WAKE COUNTY DEPARTMENT OF ENVIRONMENTAL SERVICES WELL AND SEWAGE SITE LOCATION PERMIT

PERMIT#: D005387 STATUS: A APP DATE: 02/24/1997 BLDG PERMIT#: 0981059
APPLICANT: JIM & DIANA LORD DAY PHONE: (919) 362 - 4791
ADDRESS: 1010 WELLSTONE CIRCLE FAX#: (919) 479 - 0035
CITY: APEX STATE: NC ZIP: 27502
OWNER: CHATHAM DEVELOPMENT CORP DAY PHONE: (999) 999 - 9999
ADDRESS: 102 HARDSCRABBLE DR FAX#: (919) 479 - 0035
CITY: HILLSBOROUGH STATE: NC ZIP: 27278
HD USE CD: 101 ONE-FAMILY HOUSE ORIG PERMIT#: REC?: Y
EXIST USE: TAX MAP#: 0667 0006
BEDROOMS: 4 BSMT: Y #EMPLOYEES: 0 WATER: I WASTEWATER: I GARB DISPOSAL: N
TOWNSHIP: 03 BUCKHORN JURIS: WC ZON: R80W PIN: ~~0711.03-30-1760-000~~
SUBD#: S 018 096 00 SUBD NAME: WEAVER CROSSING LOT-SEC: 1 ACRE: 6.97
IMPRV PRMT: ISSUED?: Y DATE: 04/21/1997 BY: ELC TYPE SYSTEM: IV PUMP: Y
CNSTR AUTH: ISSUED?: Y DATE: 06/25/1998 BY: ETD DATE EXPIRED: 06/25/2003
RECEIPT#: 0012759 FEE: 290.00 OP DATE: BY:
WATR SAMPL: REQ?: APPROVED?: DATE: PROPRIETARY SYS:
ST#: 8908 MI: DIR: NAME: WEAVER CROSSING DIR: TYP: RD

REVISION - DIFFERENT
LPP SITE SELECTED

ALTERNATIVE SYSTEM DESIGN
date: 5-21-98

1971
 DONOVAN L. OLIVE
 DB. 5324, PG. 63
 DB. 1991, PG. 284
 Construction Authorization
 Site Plan 0921059
 Revised 6-25-98 D5327

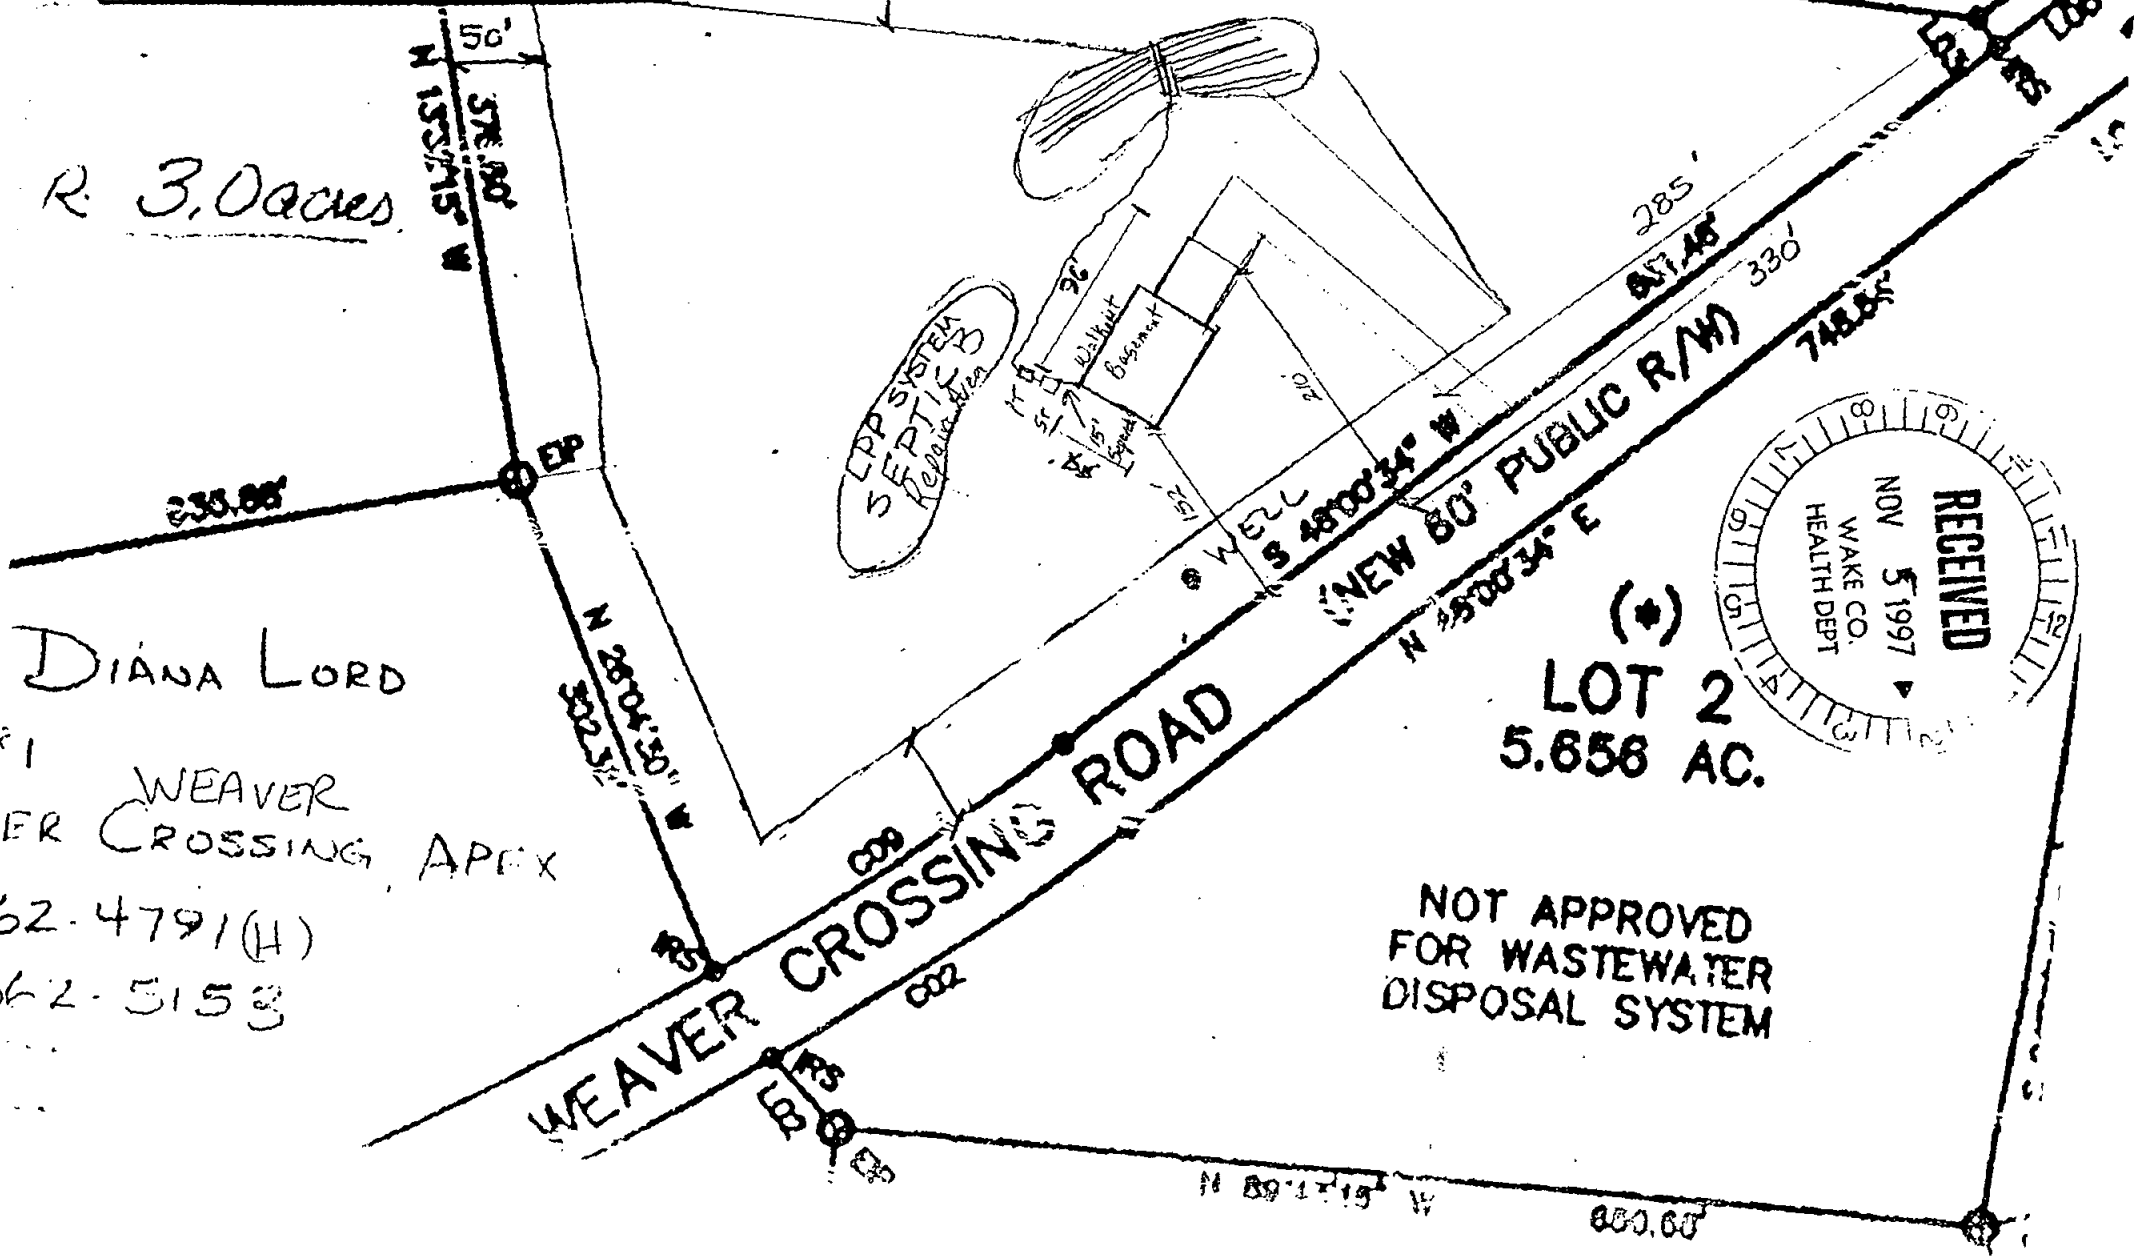
DIRECTIONS: 64 WEST, LEFT ON NEWHILL OLIVE CHAPEL RD, RIGHT INTO S/D 1ST LOT ON
RIGHT. REVISED PLANS, NEW CA ISSUED BY ETD ON 6-25-98.

OTHER CONDITIONS: Install system according to revised LPP Plans submitted by February Assoc., Inc.. Septic tank filter with riser for access required. Simplex control panel with cycle counter and elapsed time meter required as per plans. Note some lines require solid 1 1/4" pvc pipe to be used between manifold and actual drainline (this portion of pipe is not required to be sleeved). Contract with Certified Operator and Recorded Maintenance Schedule required for O.P. to be issued. Tanks must be 15' from basement and no deeper than 2' in ground. Divert water away from tanks, set panel 12" above final grade.
